CHANGES TO STANDARD INDEXES
FOR RIGID PAVEMENTS

EMMANUEL UWAIBI, P.E
PAVEMENT DESIGN ENGINEER
TEL:850-414-4372
E-MAIL:emmanuel.uwaibi@dot.state.fl.us

- The following changes are due to revisions in the January 2008 Rigid Pavement Manual:
 - Std. Index 287 – Asphalt Base Subdrainage – Page 3 of 4
 - Std. Index 305 – Standard Tie Bar Spacing - Page 1 of 4
 - Std. Index 305 – Outside Rigid pavement Slab Width – Page 4 of 4

ASPHALT BASE SUBDRAINAGE - WITH ASPHALT SHOULDER

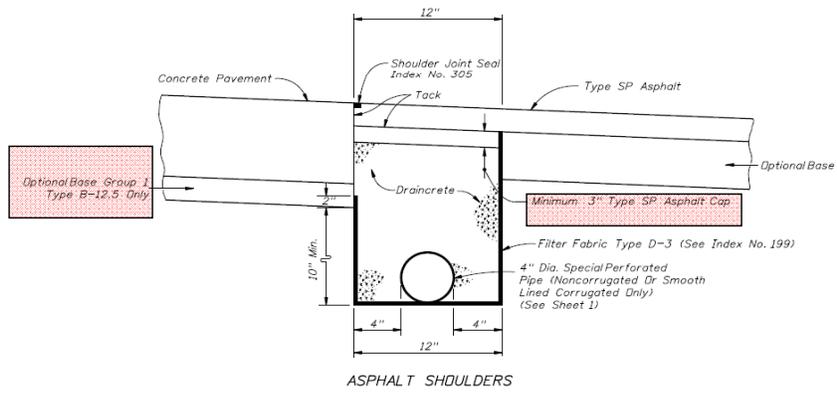
ADDED ASPHALT BASE OPTION FOR RIGID PAVEMENT

ASPHALT BASE SUBDRAINAGE - WITH CONCRETE SHOULDER

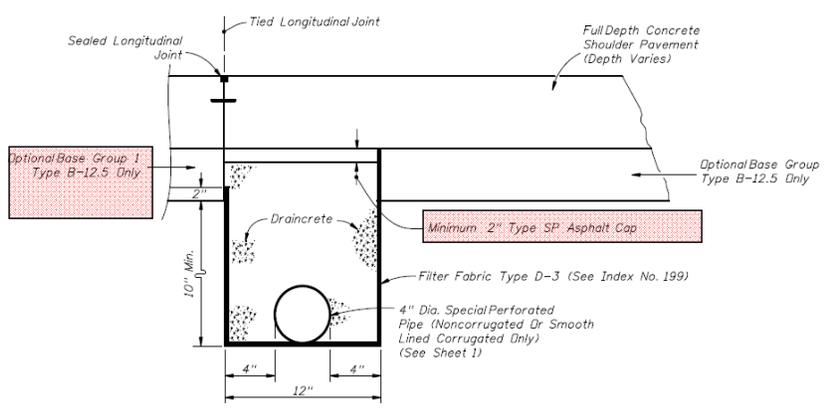
ASPHALT SHOULDERS
ASPHALT BASE SUBDRAINAGE

Changed Rigid Pavement outside Slab Width from 14' to 13'

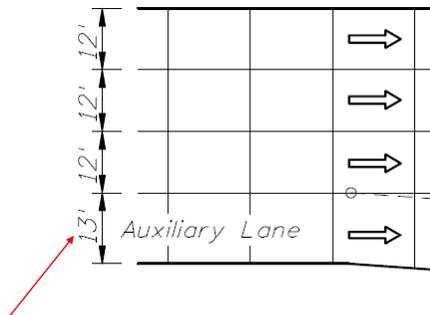
Addition of Rumble Strips to 13' outside Slab Width for Rigid Pavement
